## INVITATION TO BIDS

### Primeau Place Reclad Project Solicitation No. 6033

ADDENDUM NO. 3  
Issue Date: April 21, 2026

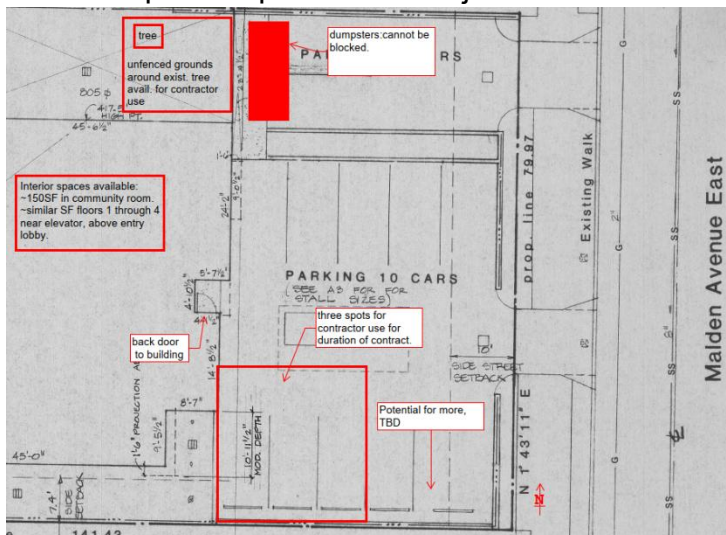
Question 33. Rooftop Parapet Siding: Detail 6/BE-600 shows new Fiber Cement Lap siding at interior side of parapet and new cladding as scheduled on the exterior. A-300 & A-301 show exterior siding to be Fiber Cement Smooth Panel "Earl Gray". Please verify interior side of parapet wall to have new lap siding, as shown in the details, and specify lap siding finish.

Response: No work on the interior side of the parapet - scope of work stops with new parapet coping. Detail and notes updated per Addendum #03.
